**CITY OF MARQUETTE
PLANNING AND ZONING
300 W. BARAGA AVENUE
MARQUETTE, MI 49855
(906) 225-0425
www.mqtcty.org**

TO: Planning Commission
FROM: Andrea Landers, Planning/Zoning Official
DATE: August 12, 2015
SUBJECT: 01-PUD-08-15 – Request for PUD Criteria Qualification for Duke LifePoint – 850 W. Baraga Ave. (PIN: 0130100, 0240013, 0514071, and 0514072)

STAFF FILE REVIEW/ANALYSIS

**RE: Preliminary PUD Plan Submittal
UP Health – Marquette Replacement Hospital**

SITE LIGHTING PLAN

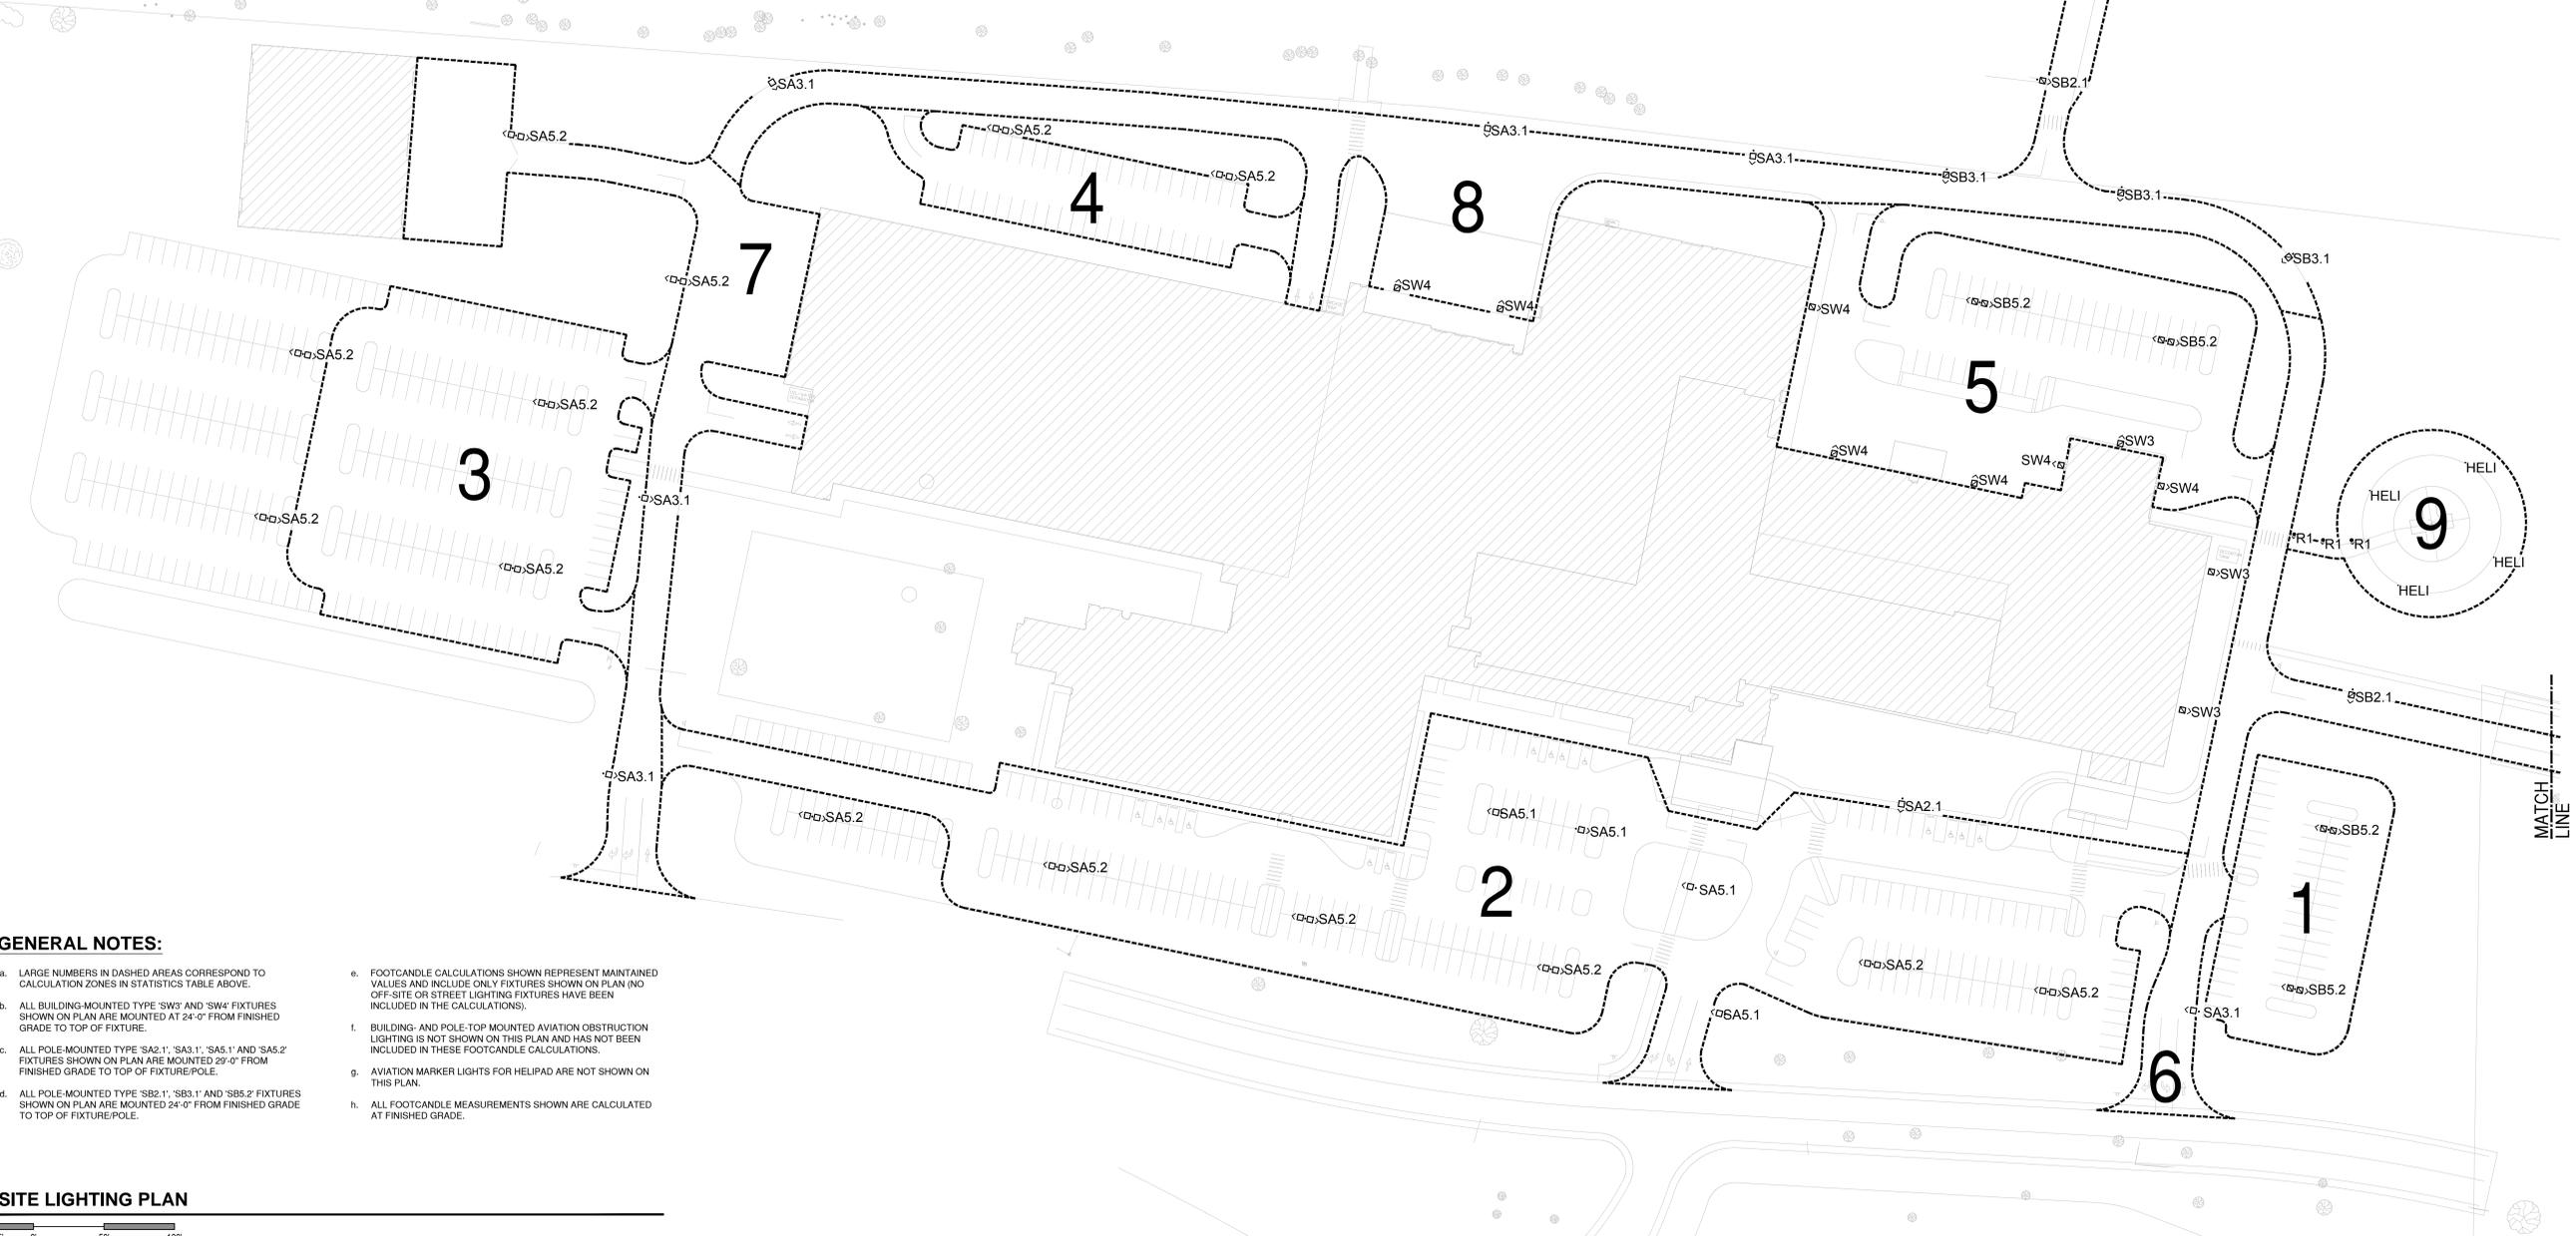
2. On Page 9, it states the "parking lot light standards not to exceed twenty-two feet in height." The ordinance allows for a maximum of 20 feet and Sheet E1.1 of the site plan states the light poles are 24 to 34 feet of height from the grade.
